ADDENDUM ONE
HIGHLAND PARK (ANDERSON AVENUE) GI DEMONSTRATION PROJECT
CONTRACT NO. S-11-001-201
CITY OF CHATTANOOGA, TENNESSEE

The following changes shall be made to the Contract Documents, Specifications, and Drawings:

III. Updates to Drawings

TRAFFIC CONTROL AND DEMOLITION PLAN
SHEET: 00C-102

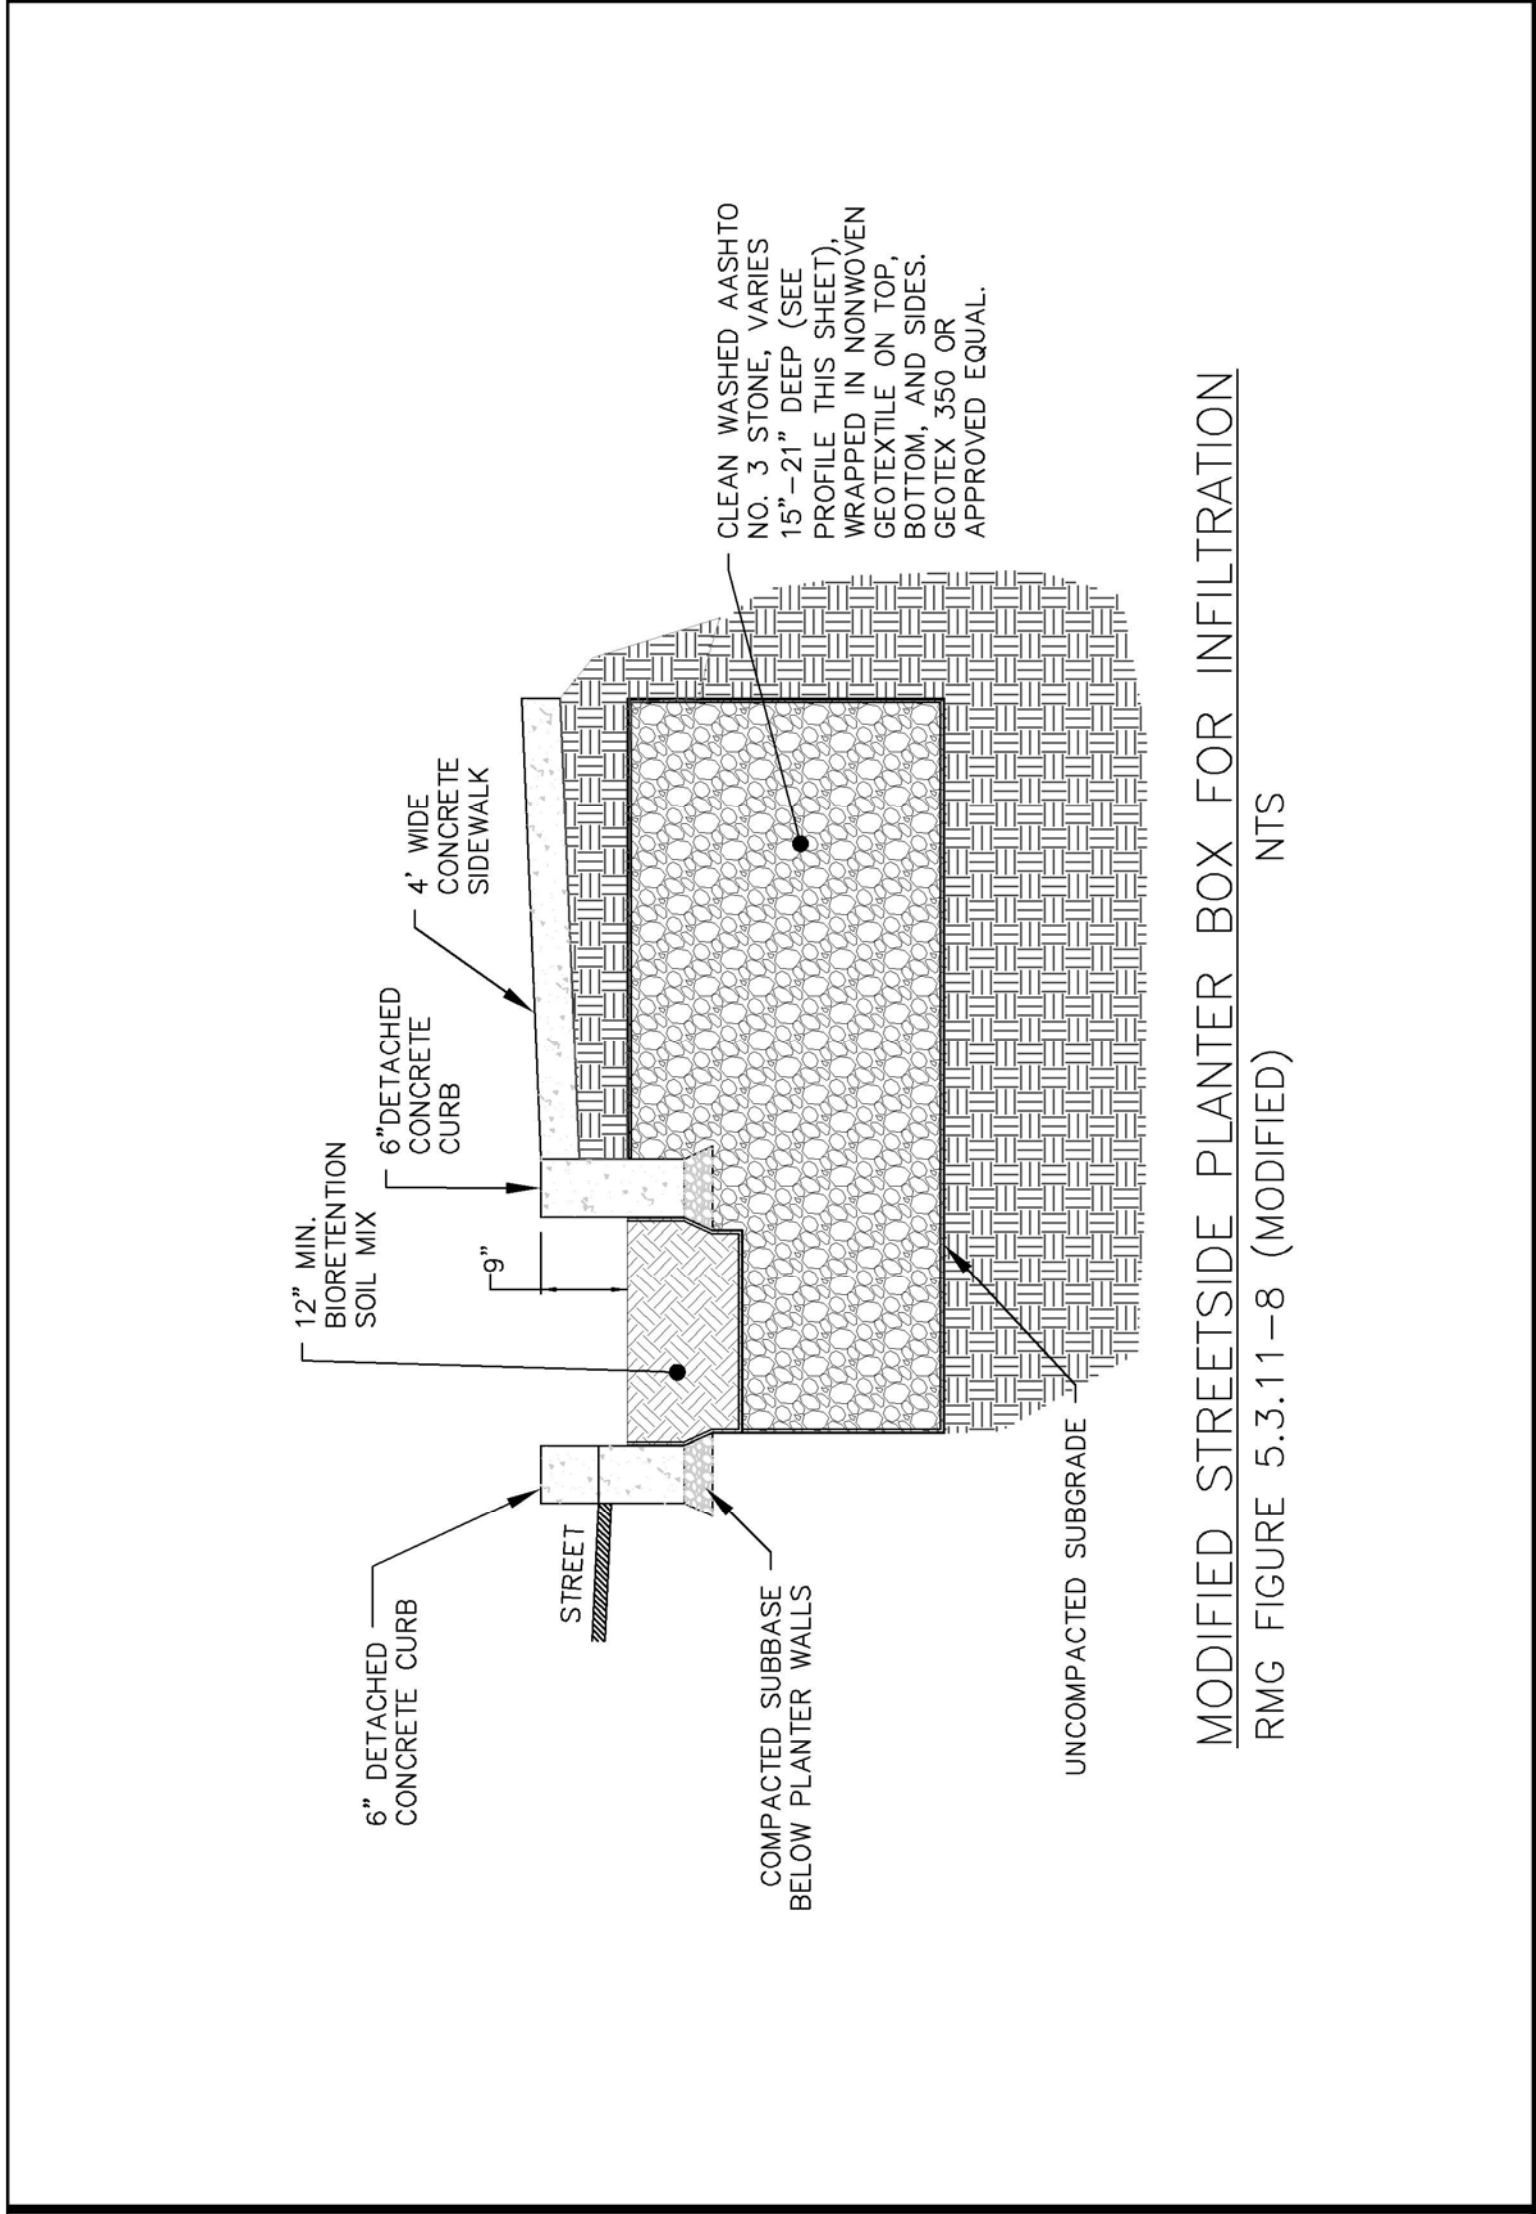
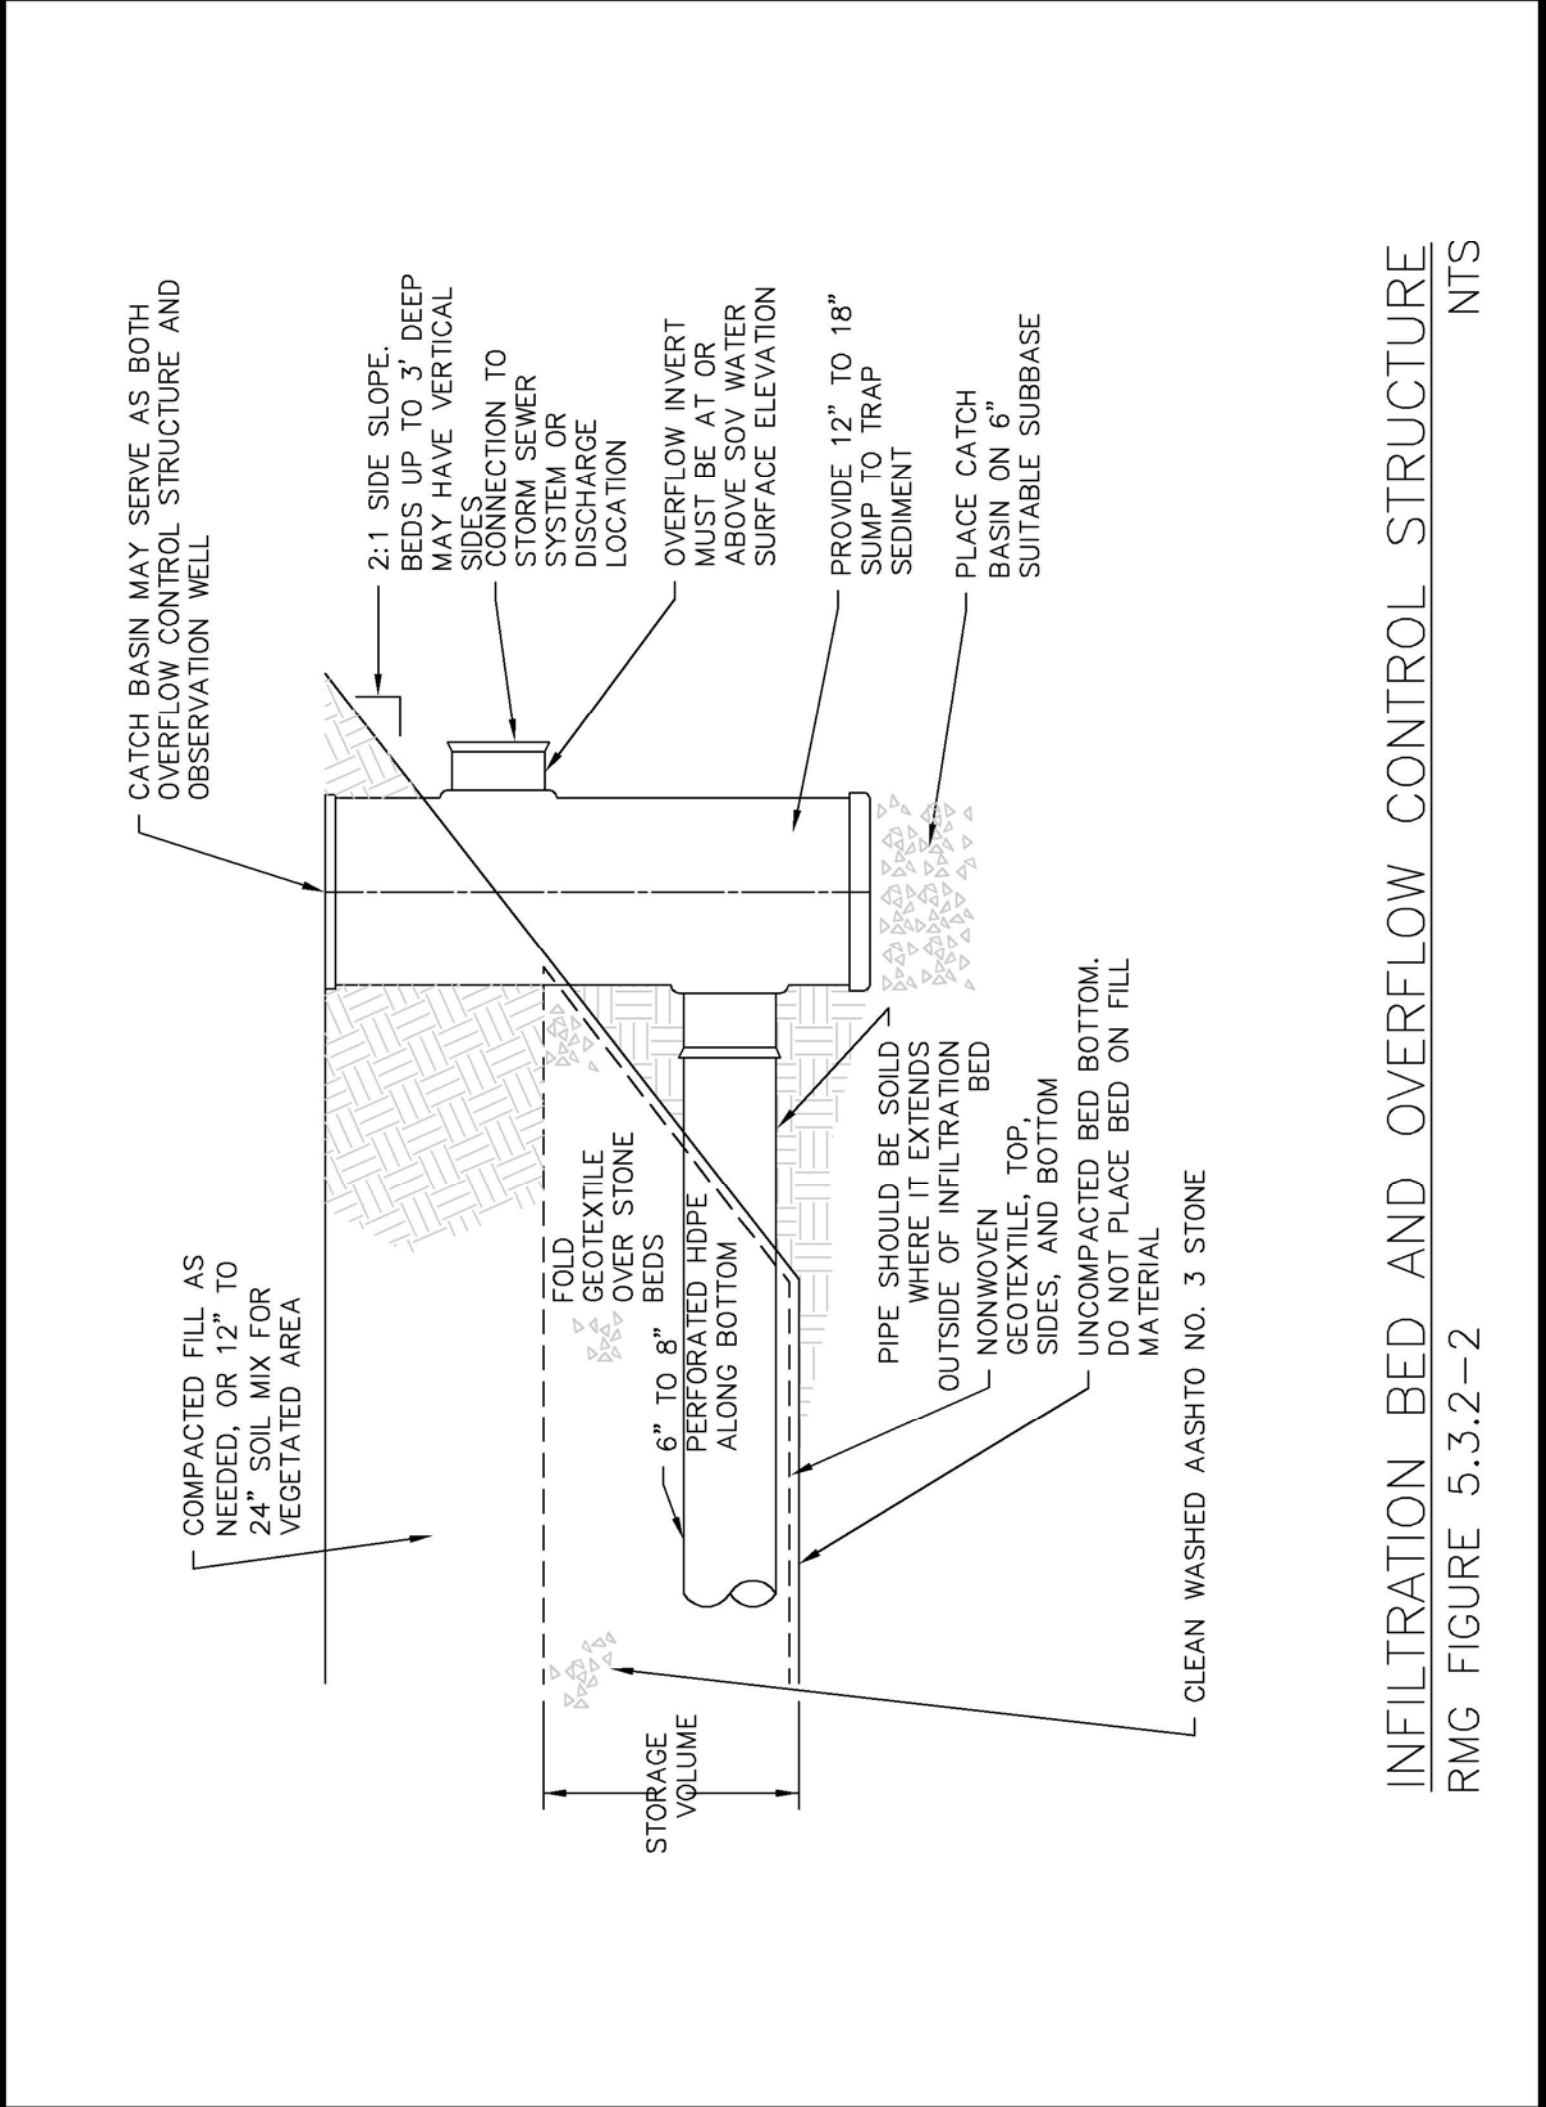
Sht 00C-102 Traffic Control Plan and demolition has been updated
